BOARD OF WATER SUPPLY

Subject: Honolulu Board of Water Supply (BWS) Comments
Concerning the Location Changes for Navy Monitoring Wells

Figure 1
Potential RHMW10 Drilling Locations
Red Hill Bulk Fuel Storage Facility
JBPHH, O'ahu, Hawai'i

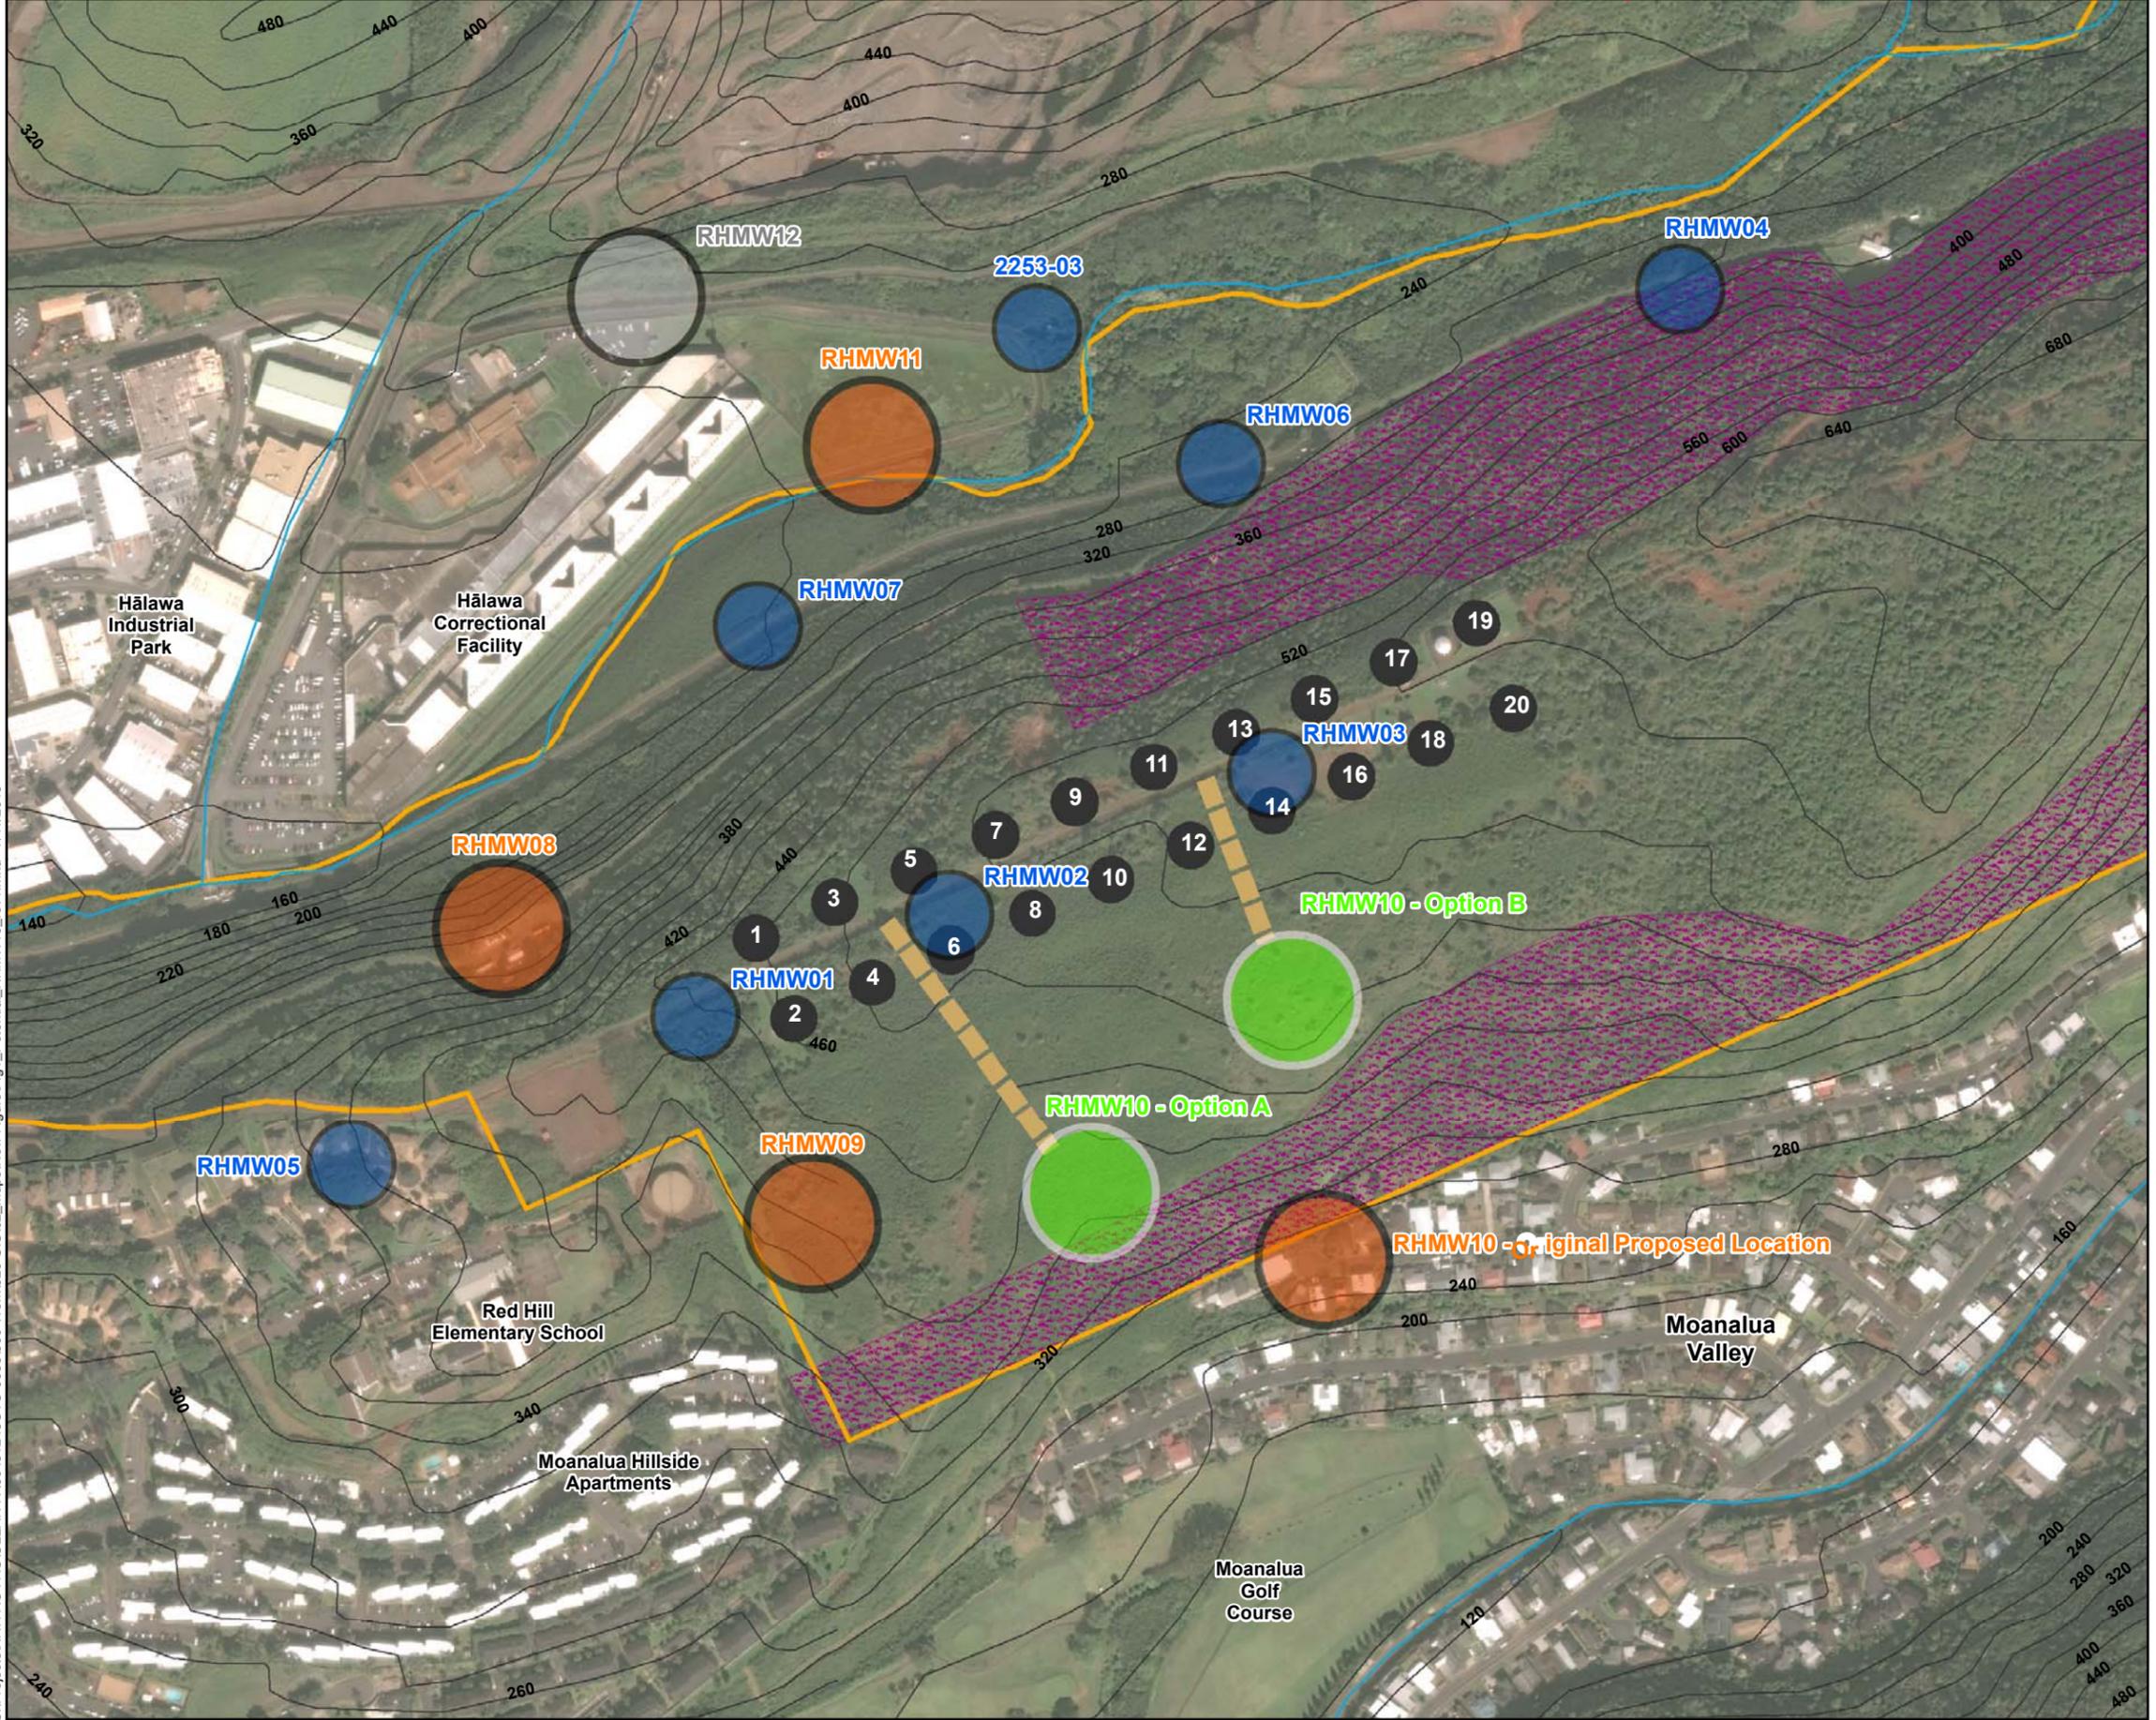
Based on your email, we understand that the reason RHMW-10 has been relocated is due to neighborhood concerns about noise and disruption during drilling. The Navy proposed relocating RHMW10 closer to the RHBFSF where it will be on Navy property (shown on the figure as Option A). The regulatory agencies prefer Option B, which is located approximately 400 feet to the northeast and also on Navy property.

The BWS finds it surprising that both Option A and Option B are proposed to be accessed from the Navy road that is located above the RHBFSF tank farm. During the Administrative Order on Consent (AOC) meetings conducted on May 10, 2016, the Navy and Navy contractors made the statement that the ridge was inaccessible to drill rigs and used this as a reason for not doing vadose zone investigation work. Apparently the Navy and its contractors have found a solution to this problem. The BWS would like to repeat its statement about the importance of vadose zone investigation. Since the ridge of the facility and surrounding area are now apparently accessible, we encourage the Parties to the AOC to plan and conduct a thorough vadose zone investigation at the RHBFSF.

to provide information about vapor intrusion into the surrounding buildings from groundwater contamination. Assuming these objectives remain unchanged, Option B appears to match the stated objectives better than Option A.

Our understanding is that this SOW has yet to be approved by the regulatory agencies and, therefore, these objectives for RHMW10 may have changed and no longer be applicable. If this is the case, the Navy should consider moving RHMW10 to the north side of the ridge (Halawa Stream side) where it would more likely encounter groundwater contamination.

Our understanding is that the Navy has proposed moving RHMW11 closer to the South Halawa Stream and southeast from its originally proposed location. The BWS favors this new location because we believe it will provide more information concerning the composition, properties, and depth of valley fill. We encourage the regulatory agencies to approve this location. In our letter to the regulatory agencies dated May 27, 2016, BWS had proposed that the Navy relocate RHMW09 to a similar location, but on the south side of South Halawa stream on Navy property.

Additionally, the Navy has proposed another location, RHMW12, may be used if the new location of RHMW11 does not meet the Navy's needs. The BWS requests that the regulatory agencies explain whether this is an alternate location to RHMW11, should the Navy be unable to secure access or whether this location is proposed in addition to RHMW11? The email indicated that the regulatory agencies still had questions about whether RHMW11 will meet the needs of the work being performed under Sections 6 & 7 of the AOC SOW. The BWS requests that the regulatory agencies indicate to the BWS exactly what these questions are.
